DIXIE-NARCO

Service Bulletin # _____

MODELS: DN174-6; DN204-6; DN246-6

SUBJECT: Cash Box Anti-Theft

Fig. 1

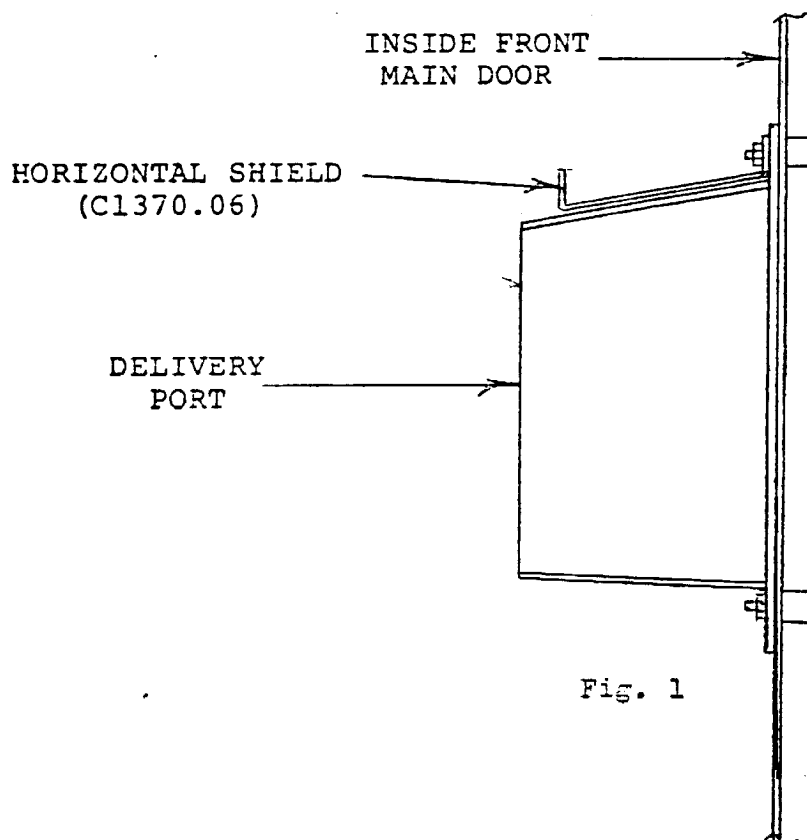
REASON: To provide a Shield which when secured to the inside of the main door prevents removal of the Cash Box if the delivery port area is vandalized.

- DO THIS:
1. Remove Nuts and washers which secure delivery port trim (4 places) at top.
 2. Position Shield as shown in Fig. #1.
 3. Replace washers and nuts and securely fasten the assembly.
 4. View is from hinge side.
